UNITED STATES PATENT AND TRADEMARK OFFICE

| APPLICATION NO. | FILING DATE | FIRST NAMED INVENTOR | ATTORNEY DOCKET NO. | CONFIRMATION NO. |
|-----------------|-------------|----------------------|---------------------|------------------|
| 10/510,424 | 04/04/2005 | Dominique Sebillé | 17170/002001 | 8851 |

Office Action Summary

DETAILED ACTION

FIG. 3A

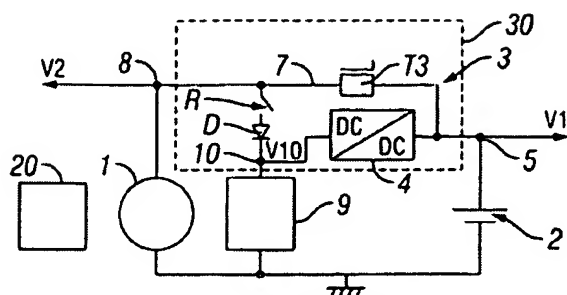
The empty diagram boxes 1, 9, 20, found in the Figures of the drawings, must be labeled with an appropriate descriptive phrase. Appropriate correction is required. Corrected drawing sheets in compliance with 37 CFR 1.121(d) are required in reply to this Office action to avoid abandonment of the application. Any amended replacement-drawing sheet should include all of the figures appearing on the immediate prior version of the sheet, even if only one figure is being amended. The figure or figure number of an amended drawing should not be labeled as "amended." If a drawing figure is to be canceled, the appropriate figure must be removed from the replacement sheet, and where necessary, the remaining figures must be renumbered and appropriate changes made to the brief description of the several views of the drawings for consistency. Additional replacement sheets may be necessary to show the renumbering of the remaining figures. Each drawing sheet submitted after the filing date of an application must be labeled in the top margin as either "Replacement Sheet" or "New Sheet" pursuant to 37 CFR 1.121(d). If the examiner does not accept the changes, the applicant will be notified and informed of any required corrective action in the next Office action. The objection to the drawings will not be held in abeyance.

2. The drawings are objected to because element 20, in amended fig.3A, is shown non-connected.

Corrected drawing sheets in compliance with 37 CFR 1.121(d) are required in reply to the Office action to avoid abandonment of the application. Any amended replacement-drawing sheet should include all of the figures appearing on the immediate prior version of the sheet, even if only one figure is being amended. The figure or figure number of an amended drawing should not be labeled as "amended." If a drawing figure is to be canceled, the appropriate figure must be removed from the replacement sheet, and where necessary, the remaining figures must be renumbered and appropriate changes made to the brief description of the several views of the drawings for consistency. Additional replacement sheets may be necessary to show the renumbering of the remaining figures. Each drawing sheet submitted after the filing date of an application must be labeled in the top margin as either "Replacement Sheet" or "New Sheet" pursuant to 37 CFR 1.121(d). If the examiner does not accept the changes, the applicant will be notified and informed of any required corrective action in the next Office action. The objection to the drawings will not be held in abeyance.
